CITY OF ALBUQUERQUE

Re: Campbell Brewery, 4814 Hardware Dr. NE
Request for Certificate of Occupancy
Transportation Development Final Inspection
Architect's Stamp dated 8-7-15 (F17D097)
Certification dated 2-1-18

Based upon the information provided in your submittal received 2-9-18, Transportation Development cannot approve the release of Certificate of Occupancy for the above referenced project.

C1

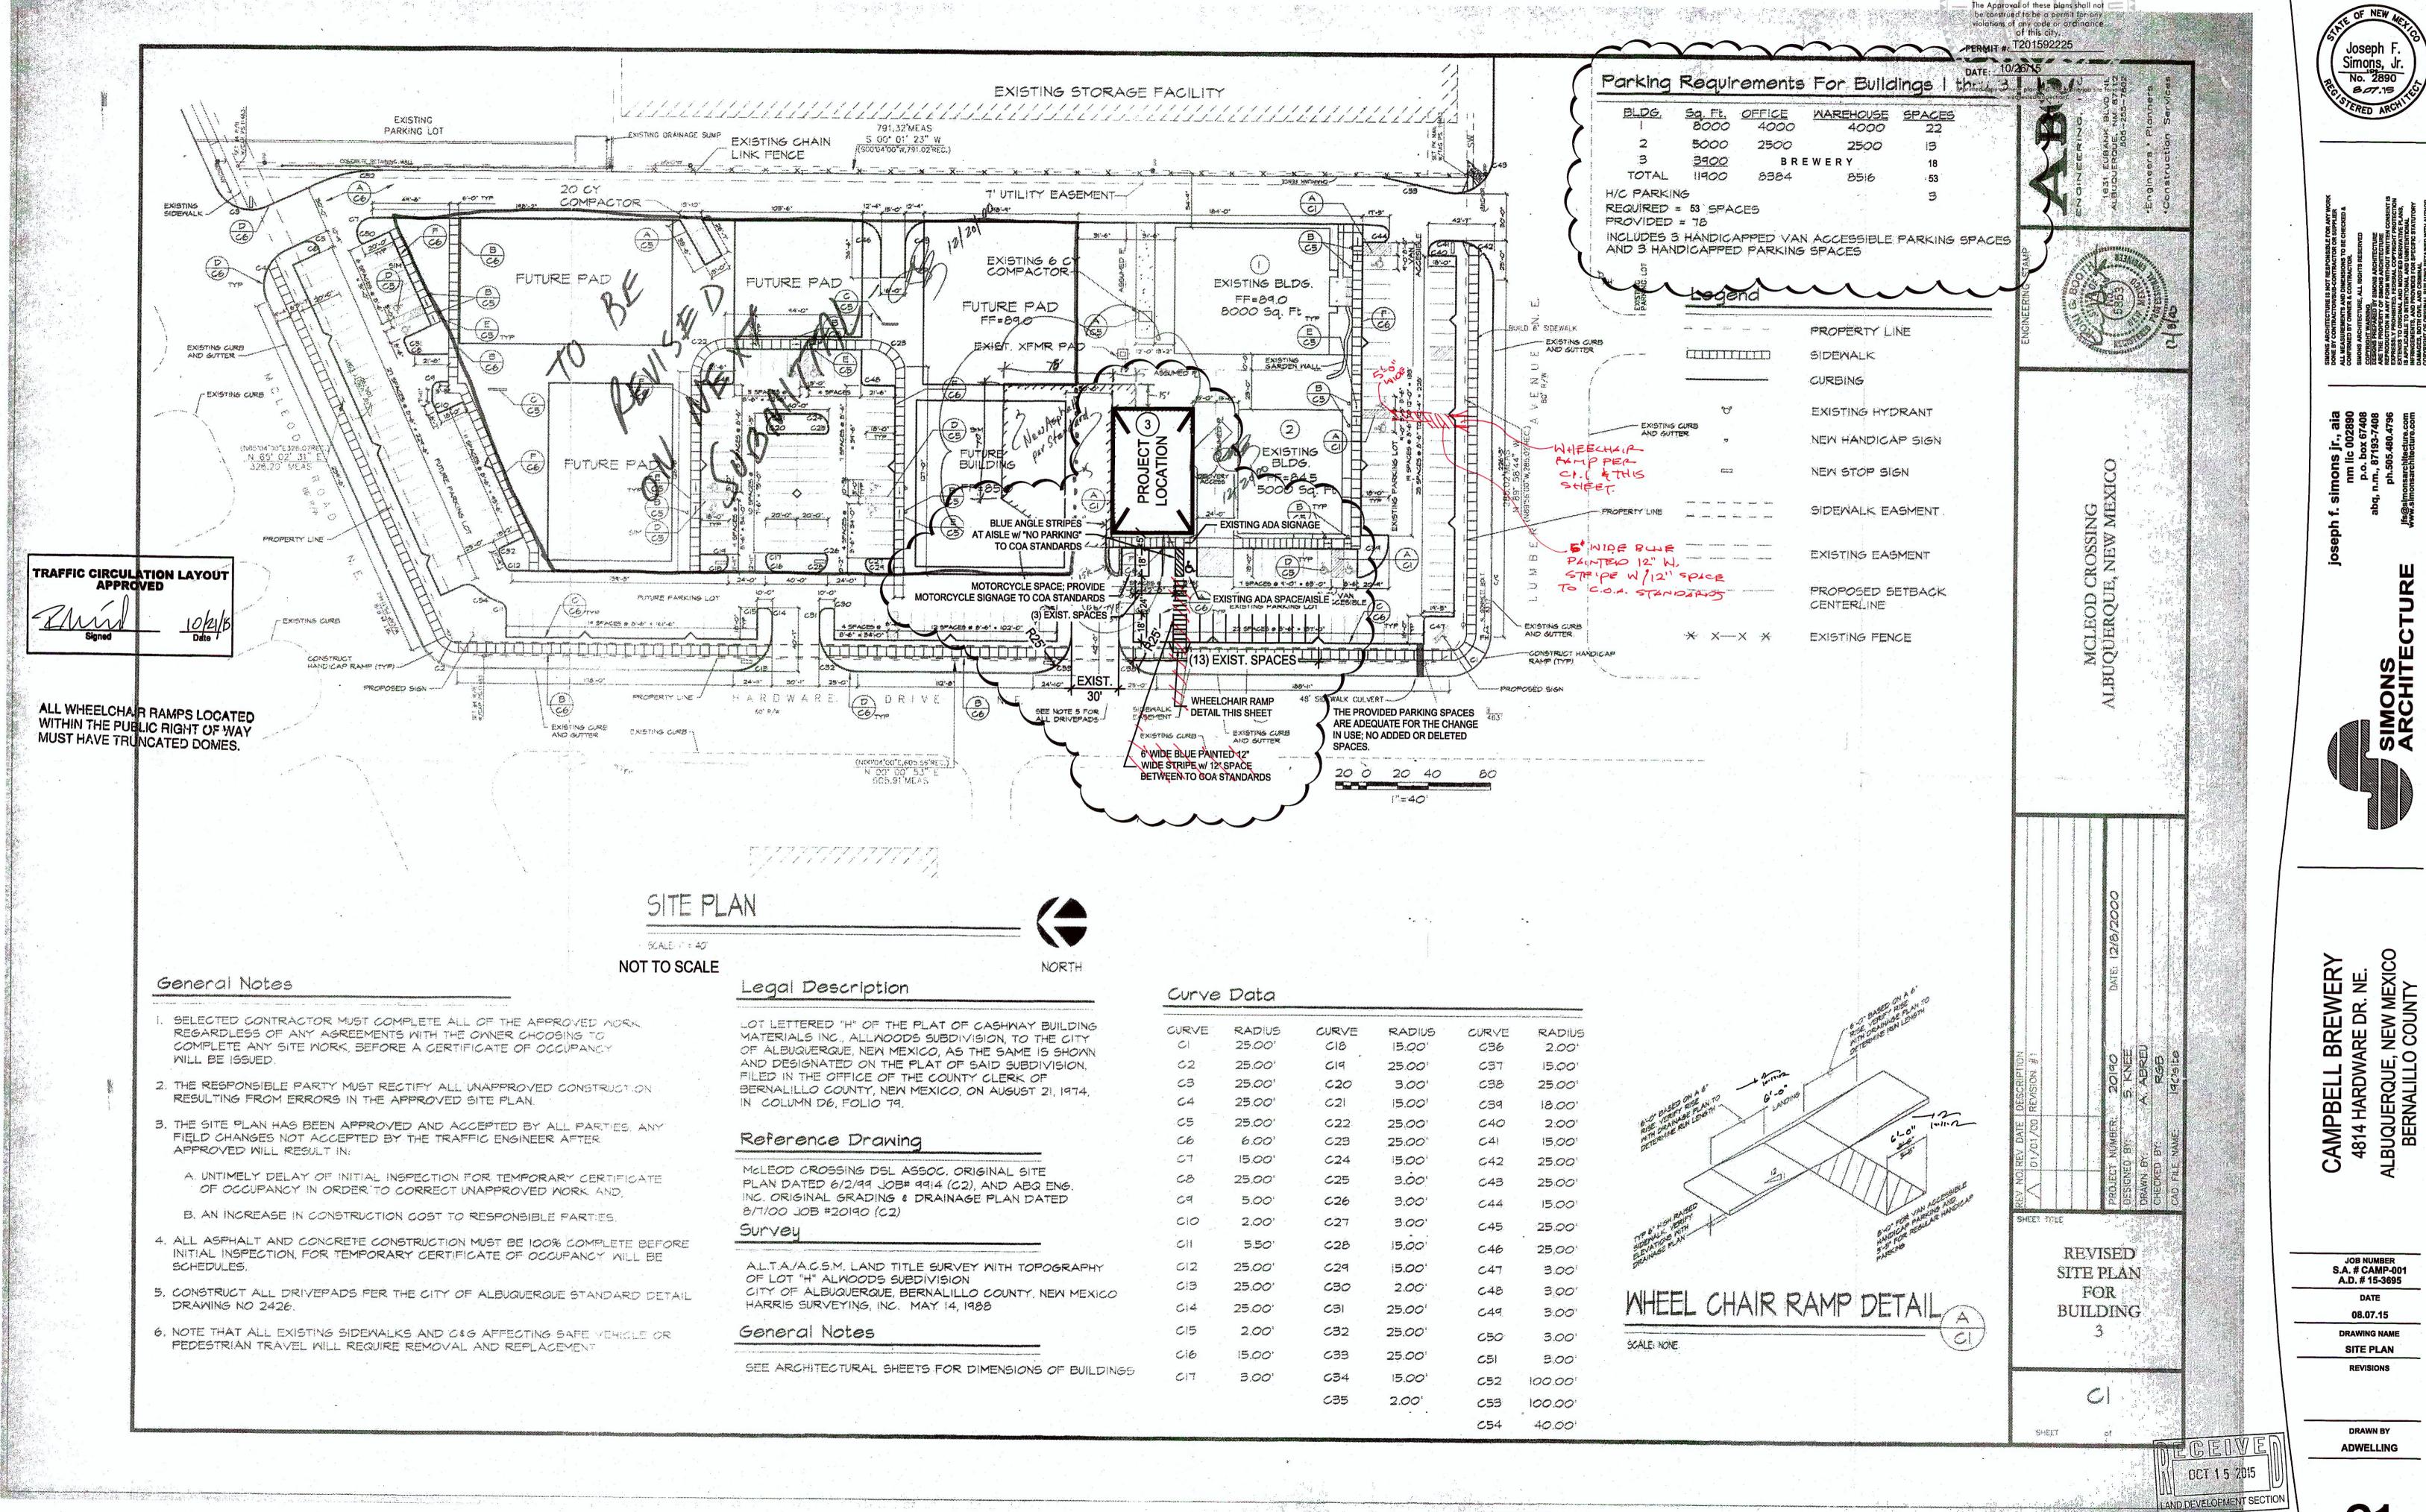
The ADA accessible parking sign must have the required language per 66-7-352.4C NMSA 1978 "Violators Are Subject to a Fine and/or Towing." Please call out detail and location of HC signs.

The ADA access aisles shall have the words "NO PARKING" in capital letters, each of which shall be at least one foot high and at least two inches wide, placed at the rear of the parking space so as to be close to where an adjacent vehicle's rear tire would be placed. (66-1-4.1.B NMSA 1978)

3. Per DPM, a 6 ft. wide ADA accessible pedestrian pathway is required from the HC parking stall access aisles to the building entrances. Please clearly show this pathway and provide details.
